<b>Title - Sujet</b> Traverse Trail Clearing & Grubbing	
<b>Solicitation No. - N° de l'invitation</b> EZ899-171514/A	<b>Amendment No. - N° modif.</b> 005
<b>Client Reference No. - N° de référence du client</b>	<b>Date</b> 2016-11-23
<b>GETS Reference No. - N° de référence de SEAG</b> PW-\$PWY-033-7889	
<b>File No. - N° de dossier</b> PWY-6-39165 (033)	<b>CCC No./N° CCC - FMS No./N° VME</b>
<b>Solicitation Closes - L'invitation prend fin</b> <b>at - à 02:00 PM</b> <b>on - le 2016-12-01</b>	<b>Time Zone</b> <b>Fuseau horaire</b> Pacific Standard Time PST
<b>F.O.B. - F.A.B.</b> <b>Plant-Usine:</b> <input type="checkbox"/> <b>Destination:</b> <input checked="" type="checkbox"/> <b>Other-Autre:</b> <input type="checkbox"/>	
<b>Address Enquiries to: - Adresser toutes questions à:</b> Siopongco, Philip PWY	<b>Buyer Id - Id de l'acheteur</b> pwy033
<b>Telephone No. - N° de téléphone</b> (604) 351-6139 ( )	<b>FAX No. - N° de FAX</b> ( ) -

<b>Destination - of Goods, Services, and Construction:</b> <b>Destination - des biens, services et construction:</b> PCA (Parks Canada) - Pacific Traverse Trail - Pacific Rim National Park - Tofino, BC

This Solicitation Amendment 005 is raised to provide

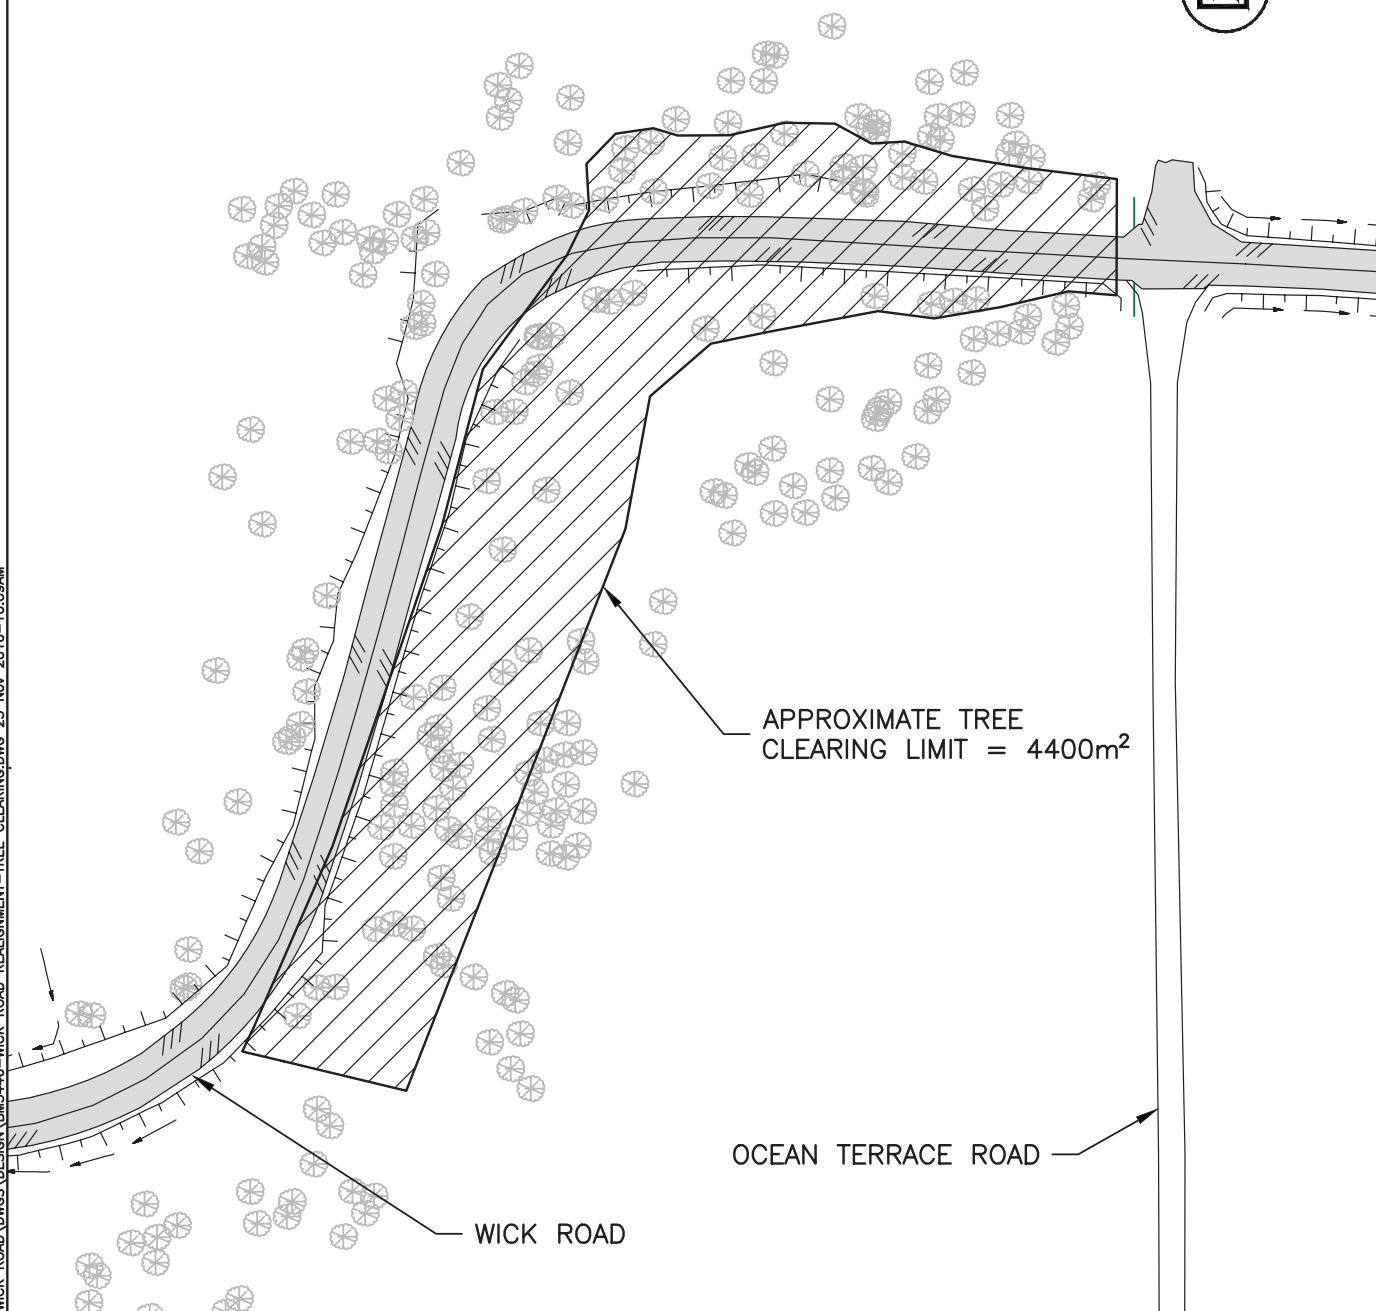
Additional clearing requirements are added for Wick Road as reflected on the Unit Price Table and identified on Figure 1 attached – Wick Road Tree Clearing.

31.1.4.b		Clearing for Wick Road	Hectare	0.44		
31.1.5		Clearing and disposal of danger trees along trail route	Each	300		
31.1.5A		Clearing and disposal of danger trees identified within the park boundary not on the trail route	Each	31
